**Ferret  
Exploration  
Company of  
Nebraska, Inc.**

March 28, 1988

Enclosed please find corrected replacement pages for the Application and Supporting Environmental Report for USNRC Commercial Source Material License. Please replace the original pages with the corrected pages. These changes were made as a result of the NDEC completeness Review.

ERRATA SHEET  
DEC Completeness Review

REV. DATE	FERRET OF NEBRASKA, INC.	
	CROW BUTTE PROJECT Dawes County, Nebraska	
	ENGLISH CREEK AND SQUAW CREEK WATERCOURSES	
	PREPARED BY: F.E.N.	
	DWN. BY: JC	DATE: 8/87
		FIGURE: 4.4-1

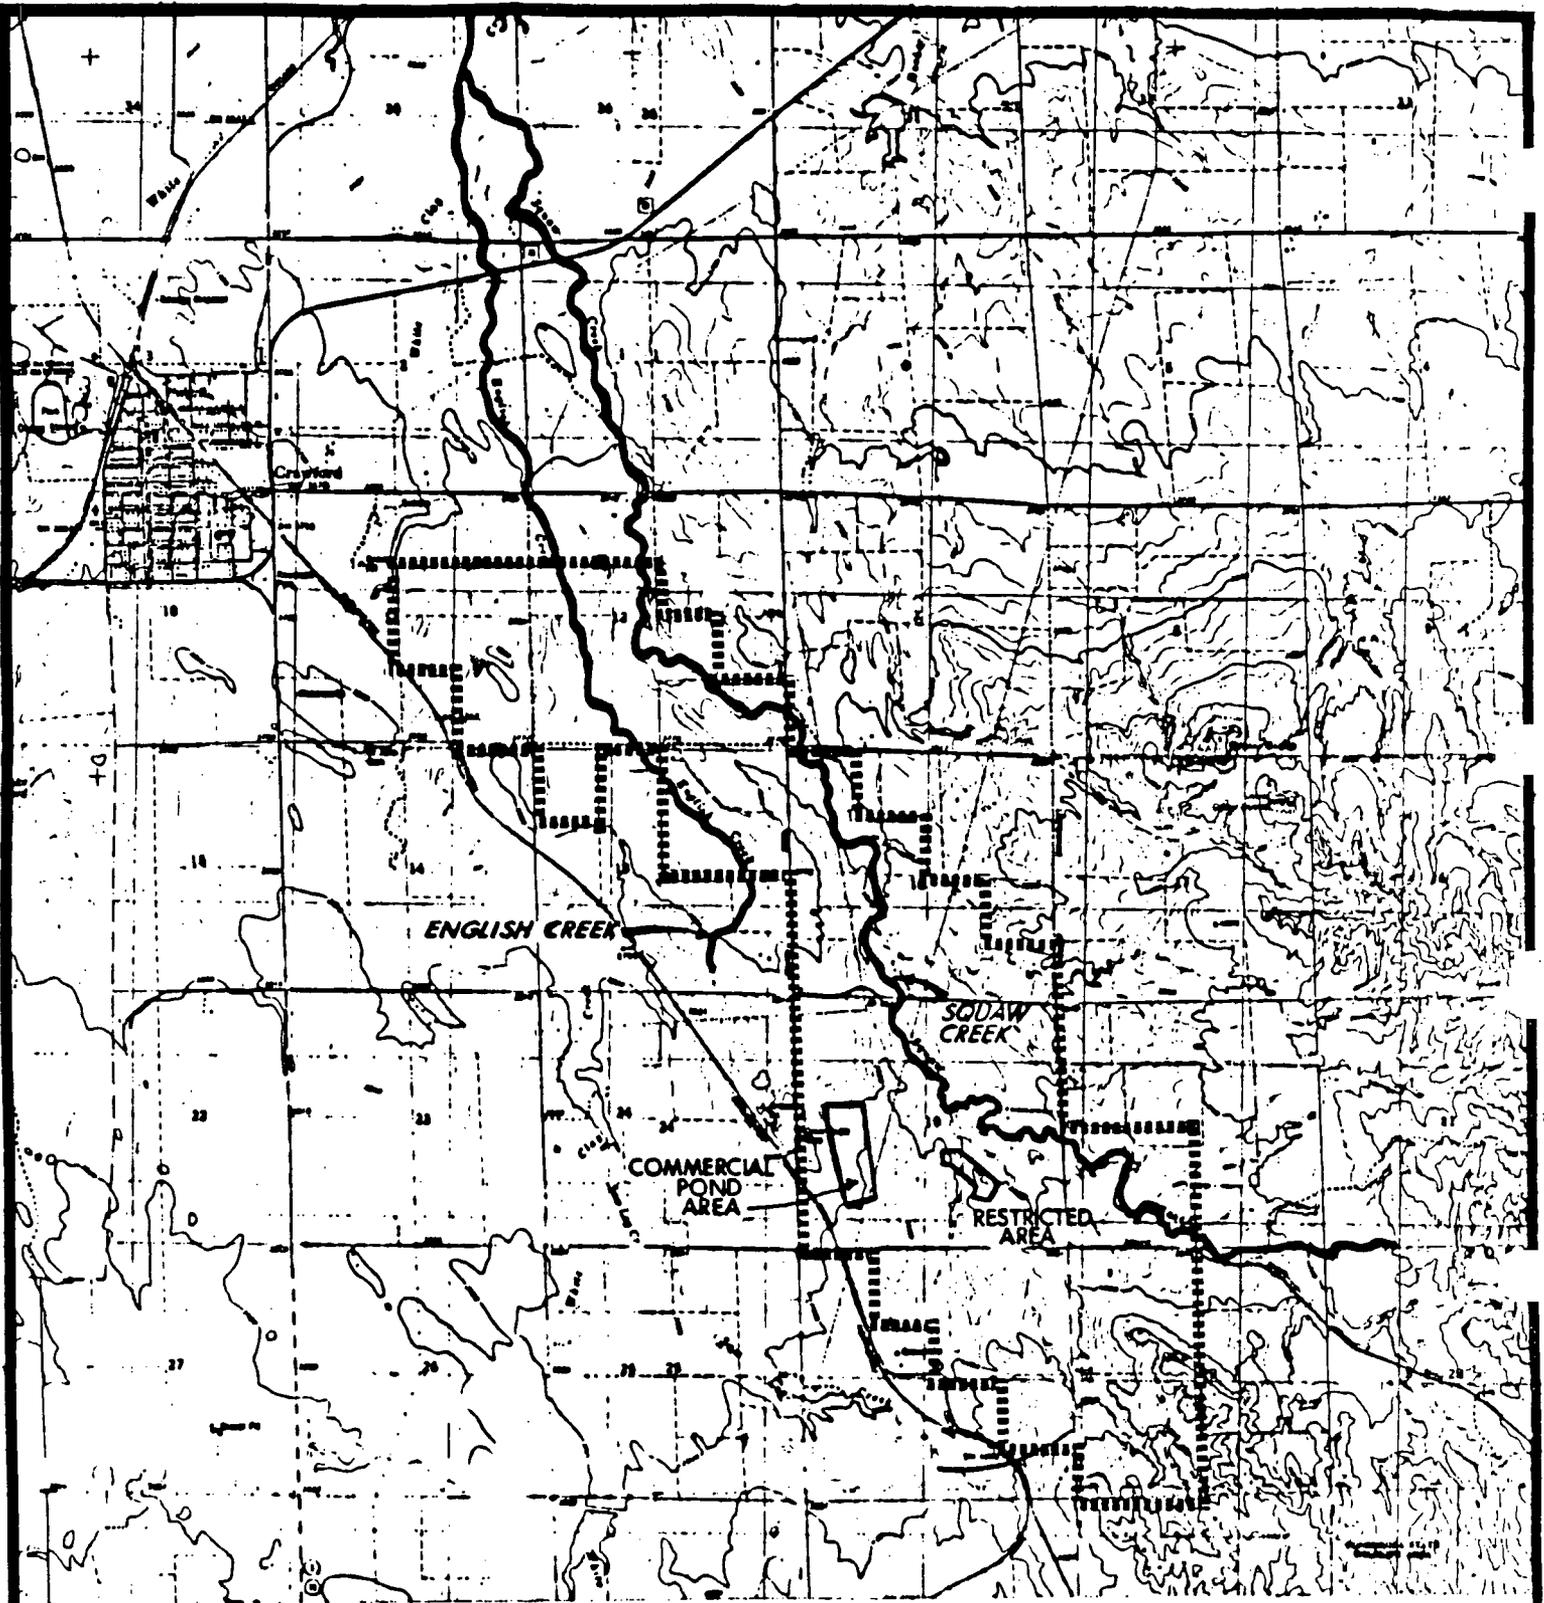
1. The following permits or construction letters must be added on Page 1 of the introduction:  
Class V 5W-11  
Septic Tank  
Pond Permit  
Water Resources Permit
2. Page 4.4(3); Figure 4.4-1, no scale.
3. Page 4.4(14); toward is misspelled.
4. Page 4.4(16); Figure 4.4-7, no scale.
5. Page 4.5(22); typing error; should read "the".
6. Page 4.5(25); P. 3 L4-5, are there some words missing?
7. Page 4.7(15); local economy has misplaced comma.
8. Page 4.8(3); L2-3 should read "published" instead of "publisted?"
9. Page 4.8(53); P.2 L1 feature number is missing.

Items 1-9 have been added or corrected on the appropriate pages.

Scales have been added to these Figures.

REV. DATE	FERRET OF NEBRASKA, INC.	
	CROW BUTTE PROJECT Dawes County, Nebraska	
	LOCATION MAP	
	PREPARED BY: F. E. N.	
	DWN. BY: J C	DATE: 8/5/87
		FIGURE: 4.4-7

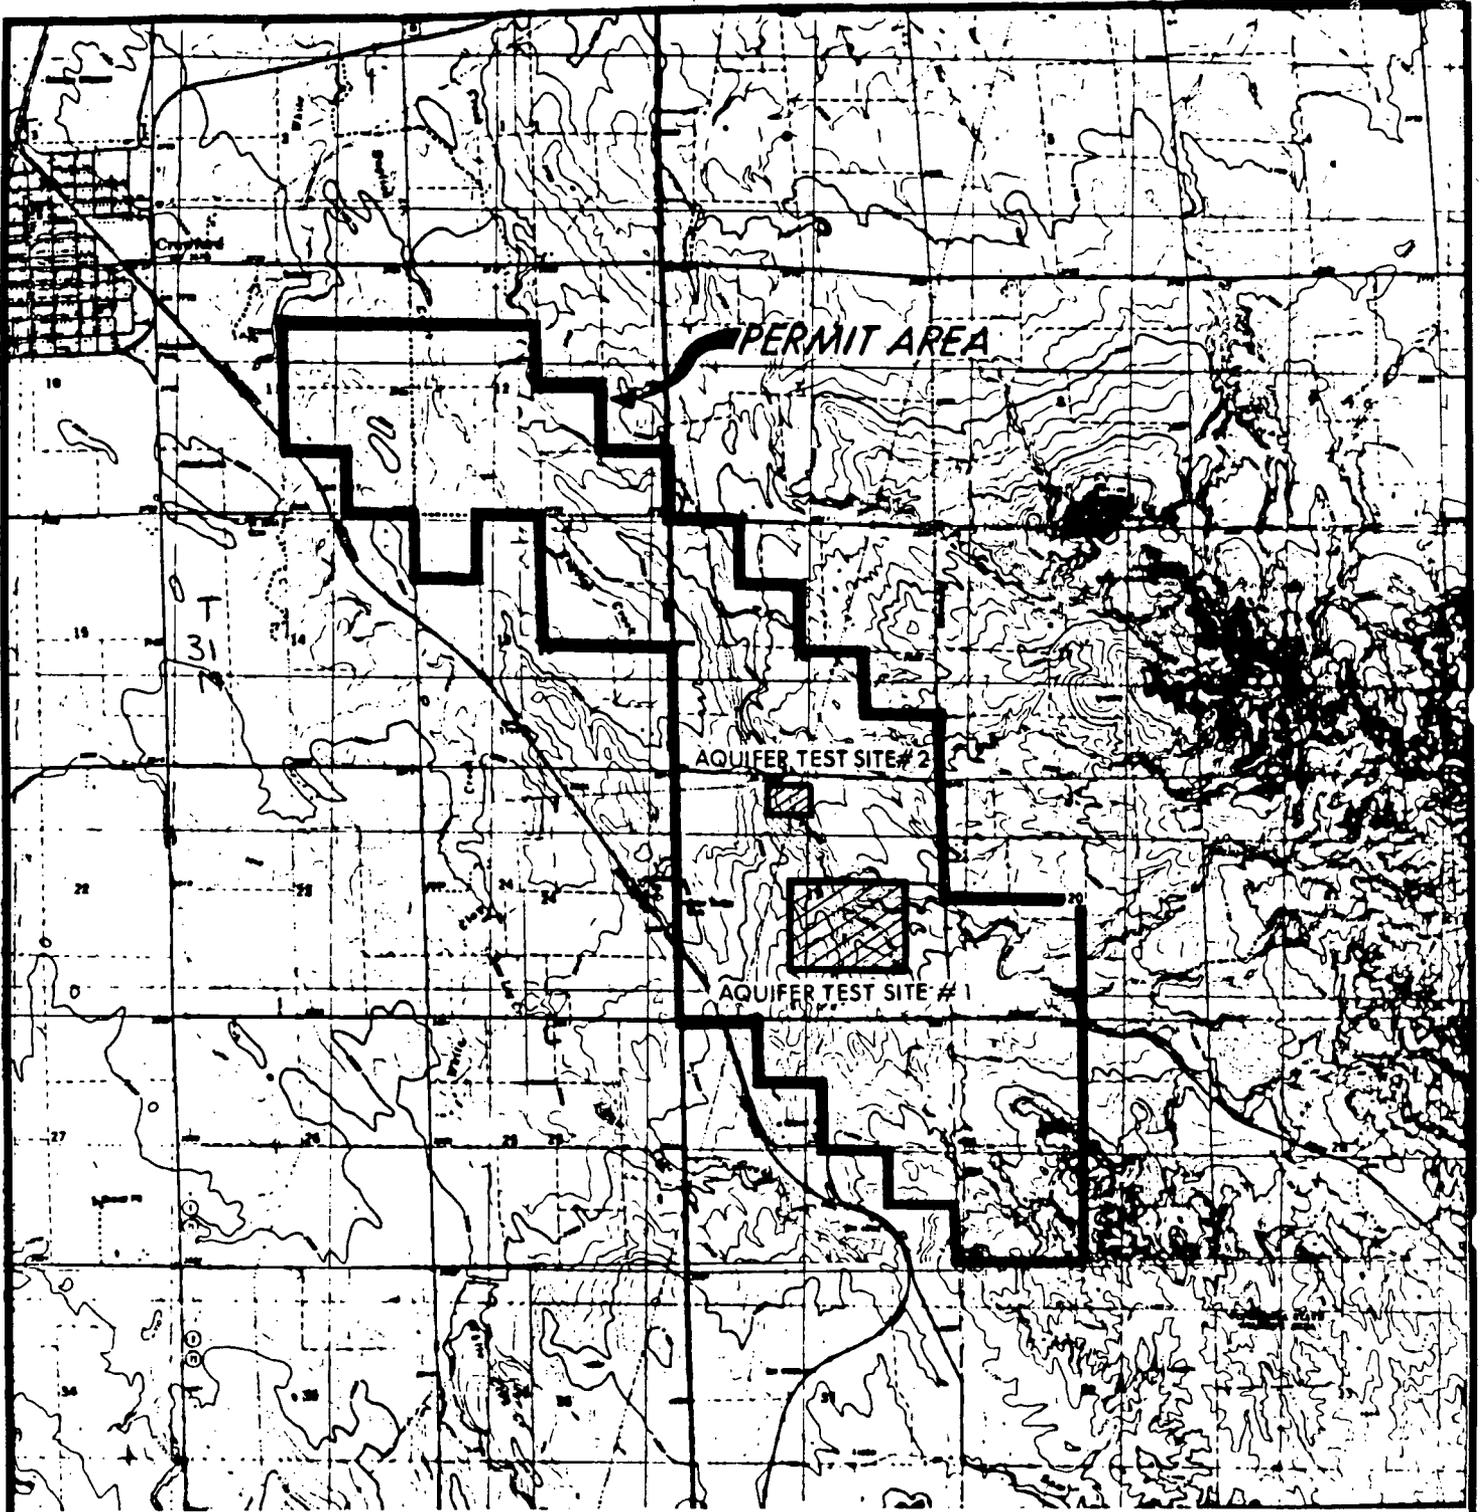
- PSF
1. Correction page 3.0(1) attached and page 1 of Introduction
  2. Corrected Figure 4.4-1 attached
  - 3.\* Corrected page 4.4(14) attached
  4. Corrected Figure 4.4-7 attached

REV DATE	FERRET OF NEBRASKA, INC.	
	CROW BUTTE PROJECT Dawes County, Nebraska	
	STRUCTURE ELEVATION OF Kp CONTACT TOP OF PIERRE (Base of Chadron Formation)	
	PREPARED BY: F.E.N.	
	DWN. BY: JC	DATE: 8/87
		FIGURE 4.5-13

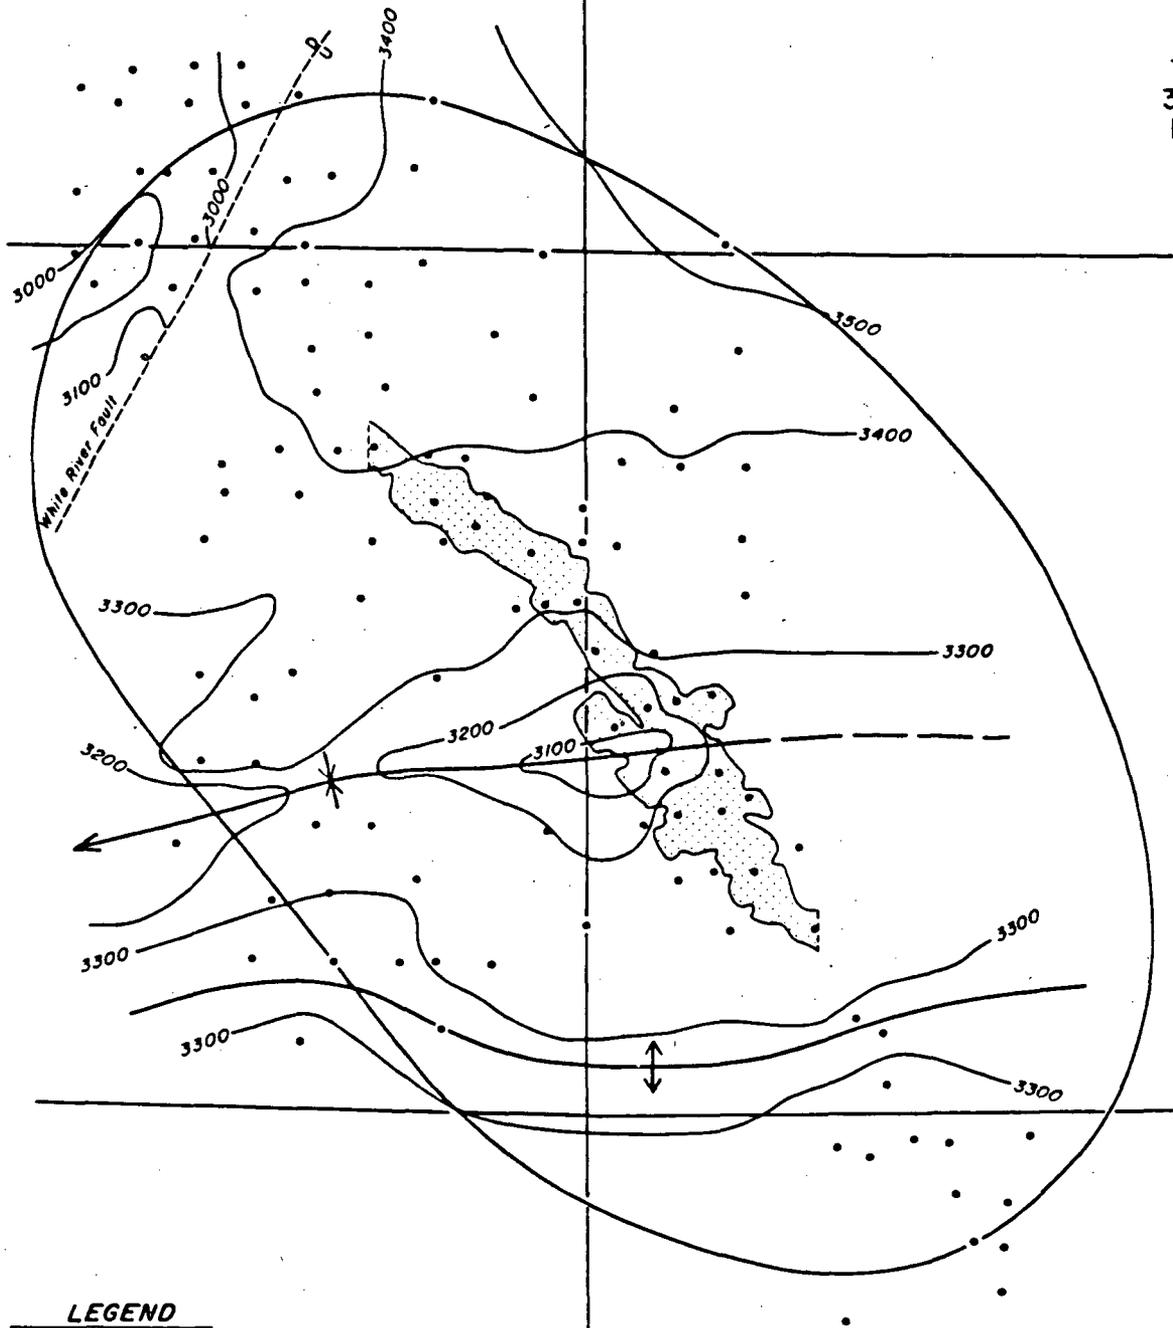
21. p.4.5(28), Figure 4.5-13: Should the structure map (Top Pierre) show anticlinal and synclinal axes? Are these actually folds or erosional highs and lows not related to folding?

REV DATE	FERRET OF NEBRASKA, INC.	
02/16/88	CROW BUTTE PROJECT Dawes County, Nebraska	
	<b>EARTHQUAKE EPICENTERS IN NEBRASKA</b>	
	PREPARED BY: F.E.N.	
	DWN. BY: JC	DATE: 8/87
		FIGURE 4.5-15

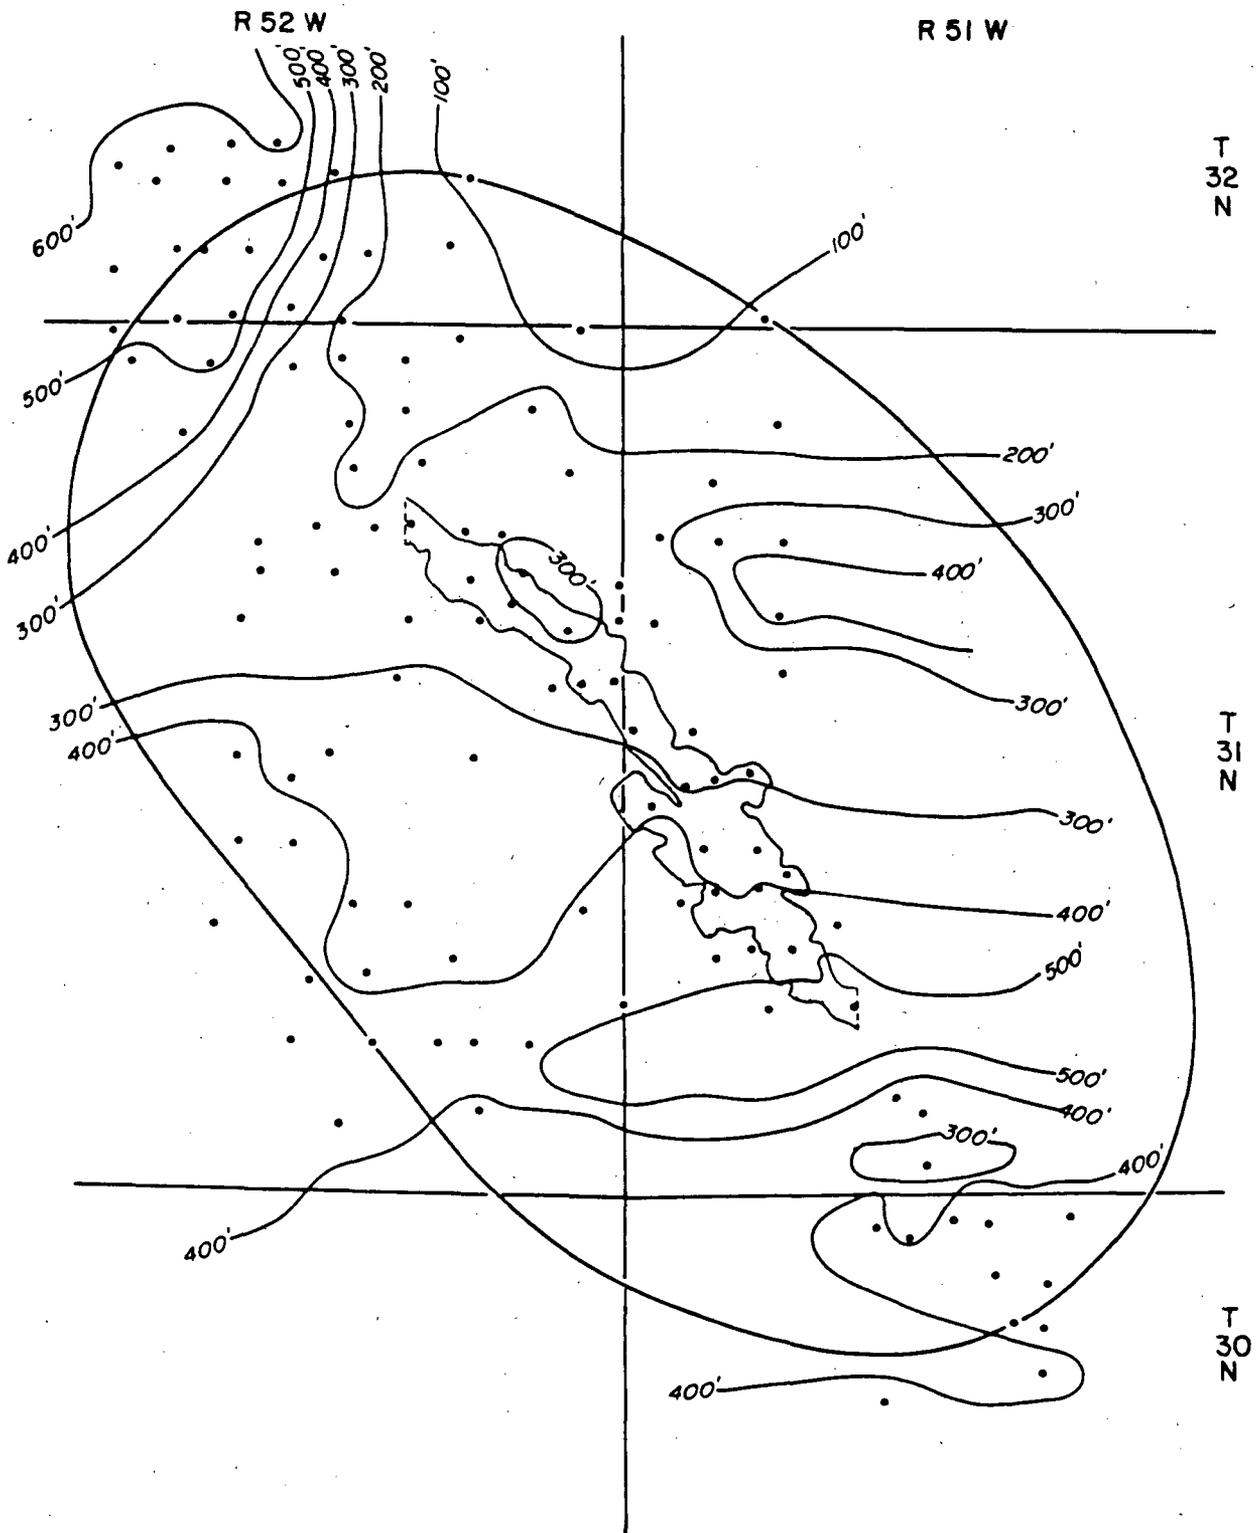
15. Section 4.5 replaced
  16. See page 4.6(3) and page 1 of Introduction
- JA
1. Figures 4.2-1 replaced earlier; Figures 4.4-1 and 4.4-7 replaced by PSF #2 and PSF #4; Corrected Figure 4.5-15 attached
